DEVELOPMENT REVIEW BOARD REPORT

CASE NUMBER/ PROJECT NAME	87-DR-2004#5 Bank of America @ Hayden Peak Crossing Pad B		
LOCATION	20301 N. Hayden Road		
REQUEST	Request approval of a site plan, elevations and landscaping for a new branch bank on Pad B at the Hayden Peak Crossing shopping center.		
OWNER	Jones Lang La Salle Americas 602-523-6640	ENGINEER	Norman Engineering Group Inc. 602-371-0397
ARCHITECT/ DESIGNER	Gensler 602-523-4901	APPLICANT/ COORDINATOR	Scott McCage Gensler 602-523-4901
BACKGROUND	<p>Zoning. This site is part of a larger commercial shopping center zoned C-3 PCD ESL (Highway Commercial District, Planned Community Development, Environmentally Sensitive Lands). This commercial center is in various phases of development.</p> <p>Adjacent Uses:</p> <ul style="list-style-type: none">• North: Multi-family residential, zoned R-4 PCD ESL (Townhouse residential, Planned Community Development, Environmentally Sensitive Lands)• East/South: Single-family residential, zoned R1-5 PCD ESL (Single-family residential - 4,700 square feet, Planned Community Development, Environmentally Sensitive Lands)• West: Unimproved park and open space, zoned OS PCD (Open Space, Planned Communit

DR-1

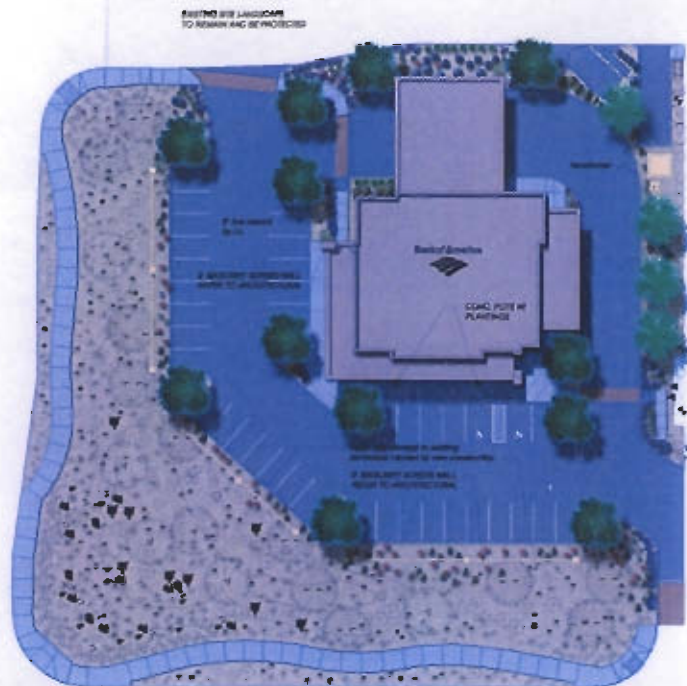
1. SIGNS SHALL BE BY SEPARATE SUBMITTAL AND PERMIT.
2. ALL ROOF-TOP MECHANICAL EQUIPMENT SHALL BE SCREENED TO THE HEIGHT OF THE TALLEST MECHANICAL UNIT. INDICATE MECHANICAL EQUIPMENT AND THE ROOF DOCK AS DASHED LINES ON THE ELEVATION DRAWINGS, AND LABEL AS MECHANICAL EQUIPMENT AND ROOF-DOCK BEYOND.

3. ROOF DRAINAGE SYSTEMS SHALL BE INTERIOR, EXCEPT THAT OVERFLOW SCUPPERS SHALL BE ALLOWED.
4. THE PLANT PALETTE PROPOSED SHALL BE THE SAME AS THE OVERALL CENTER.

5. FIFTY PERCENT OF TREES SHALL BE NATURAL, AS DEFINED IN ARTICLE II OF THE ZONING ORDINANCE. ON THE LANDSCAPE PLANS, INDICATE BOTH THE COMPLAINT CALIPER AND INDUSTRY STANDARD BOX SIZE FOR THAT CALIPER IN THE PLANT PALETTE (SECTION 10.50.01, ZONING ORDINANCE).

6. ALL PLANT SPECIES SHALL BE SELECTED SOLELY FROM THE ARIZONA DEPARTMENT OF WATER RESOURCES LOW WATER USE / DROUGHT TOLERANT PLANT LIST AND THE COLD INDIGENOUS PLANT LIST.

7. ALL FIXTURES SHALL BE ROMA FULL-CUT OFF, AND DIRECTED DOWNWARD.
8. NO FIXTURE SHALL BE MOUNTED HIGHER THAN 20 FEET.
9. NO INDIVIDUAL LAMP SHALL EXCEED 250 WATTS.

10. ALL FIXTURES AND ASSOCIATED HARDWARE, INCLUDING PIGS, SHALL BE FLAT OR DARK BRONZE.
11. THE MAINTAINED MAXIMUM AND AVERAGE MAINTAINED HORIZONTAL ILLUMINANCE AT GRADE SHALL NOT EXCEED 1.5 AND 0.8 RESPECTIVELY.

12. THE INITIAL VERTICAL ILLUMINANCE (MAXIMUM SPILL DIRECTLY OUT OF THE PROPERTY) AT 8 FEET ABOVE GRADE AROUND THE ENTIRE PROPERTY LINE SHALL NOT EXCEED .3 FOOTCANDLES.
